Access Compliance Report

Public Rights-of-Way

(Curb Ramps)

Intersection ID: 51370	Main Street: UNIVERSITY_POINTE_BV	Cross Street: IKEA_BV	Location: SE
ADA ID: 7F29D439BC1B	Ramp Type: PerpDiag	Initial Pass/Fail: Fail	Overall Compliance: No
Severity Score: 25			
Codes/Mitigation Info/Possible Solution		Field Measurements/Component Compliance

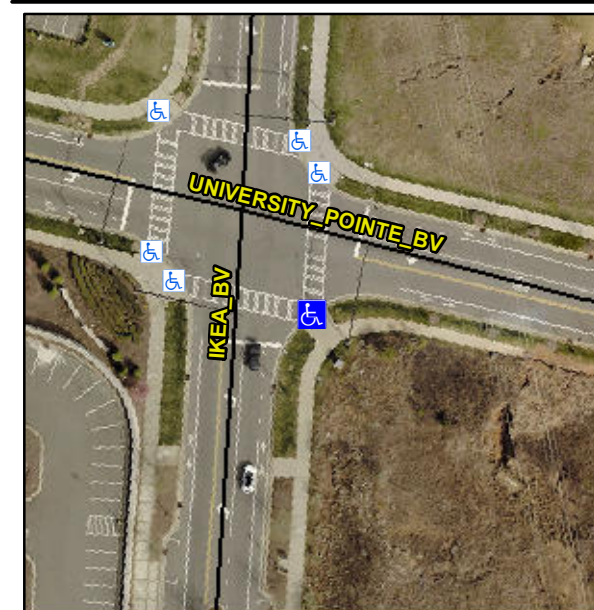
Not Found, R304.5.3

Compliance	Description	Data	Compliance	Description	Data
N/A	Ramp Length (in)	138.0	Yes	Ramp Slope (%)	6.5
Yes	Ramp Width (in)	58.0	No	Ramp XSlope (%)	10.0
N/A	Flare Type LT	N/A	N/A	Flare Type RT	N/A
N/A	Flare Slope LT (%)	N/A	N/A	Flare Slope RT (%)	N/A
N/A	Flare Traversable LT?	N/A	N/A	Flare Traversable RT?	N/A
N/A	Landing Length (in)	N/A	N/A	DWS Provided?	N/A
N/A	Landing Width (in)	N/A	N/A	DWS Contrast?	N/A
N/A	Landing Slope (%)	N/A	N/A	DWS Length (in)	N/A
N/A	Landing X Slope (%)	N/A	N/A	DWS Full Width?	N/A
N/A	Landing Curb? (Y/N)	N/A	N/A	DWS Offset (in)	N/A
N/A	Shared Landing?	N/A			
N/A	Gutter Ponding?	N/A	N/A	Gutter Slope (%)	N/A
N/A	Gutter Lip Ht (in)	N/A	N/A	Gutter X Slope (%)	N/A
N/A	Painted X Walk1?	Yes	N/A	Painted X Walk2?	Yes
	X Walk 1 Direction	To N		X Walk 2 Direction	To W
N/A	X Walk 1 Width (in)	112.0	N/A	X Walk 2 Width (in)	112.0
	X Walk 1 Slope (%)	5.5		X Walk 2 Slope (%)	5.4
	X Walk 1 X Slope (%)	3.8		X Walk 2 X Slope (%)	6.6

Remove & Replace Curb Ramp With Two New Directional Ramps or Equivalent.
